Thoughts on Proposed Text for CDMII Extender / CDXS Sublayer

IEEE 802 Mar 2016 Plenary
Macau, China sUBL

- Comment # 33 – CDXS Sub-clause yet to be completed
- This presentation is intended to initiate discussion on text for Clause 118 CDMII Extender and CDMII Extender Sublayer (CDXS)

Update Figure 118-1

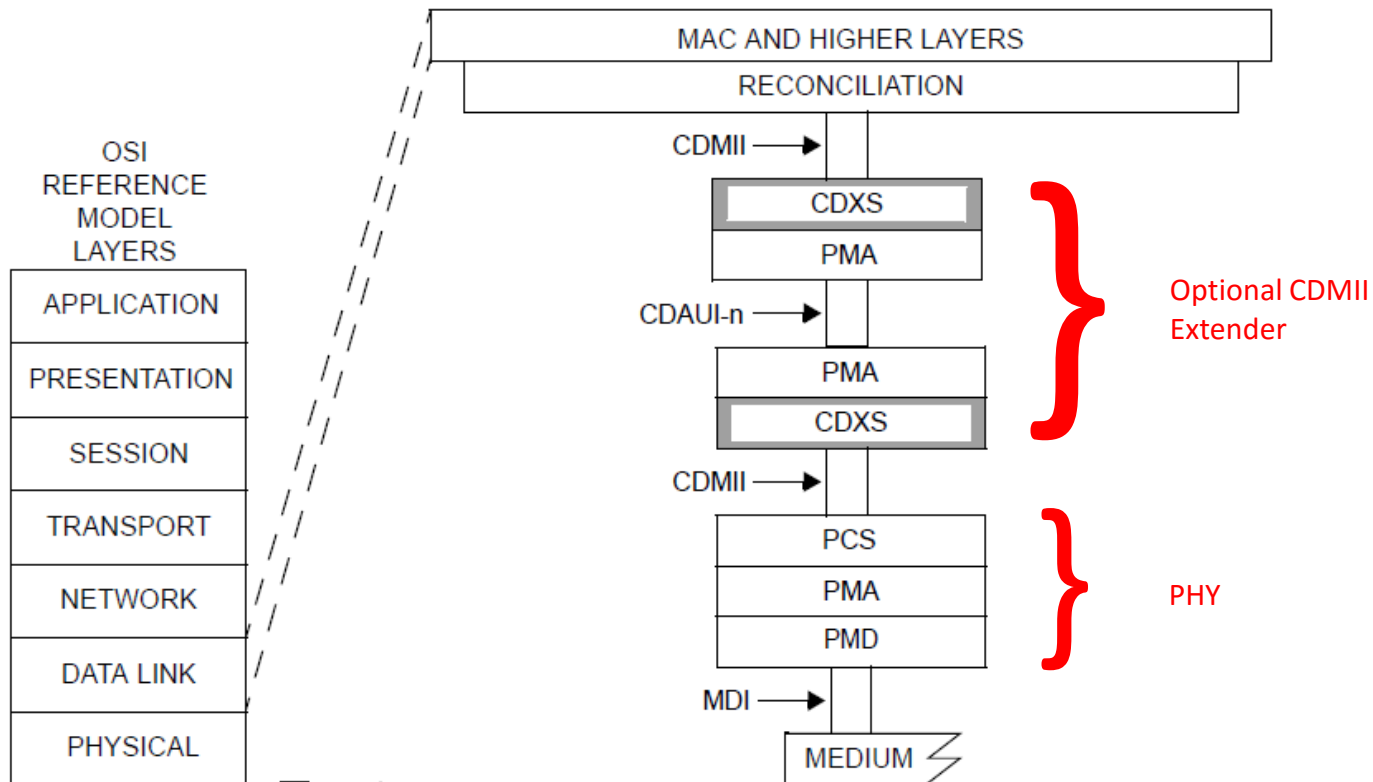
The CDMII Extender with the optional Energy-Efficient Ethernet (EEE) capability (see 78.3).... NEED OTHER TEXT??
